Product Change Notification (PCN)

PCN #	Molex Part #
508345	1062673000
508345	1062673002

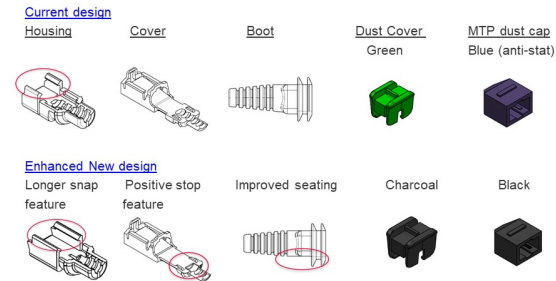
- US Conec discontinued current design of Housing, Cover and Boot and is selling Enhanced new design now
- US Conec changed color of Prizm LT dust cap from Green to Charcoal PEI
- US Conec discontinued MTP Anti-static dust cap (no change to the form or fit, material and color change only, Blue to Black)
- MTP boot – Molex is unifying its design offering by removing the heat shrink and extending boot.  Current  New
- Product Impact
 - No impact to fit or function. See previous slide for impact to form.
- Part Number Impact
 - See attached impacted parts list
- Qualification Reports and samples available upon request after the date shown above
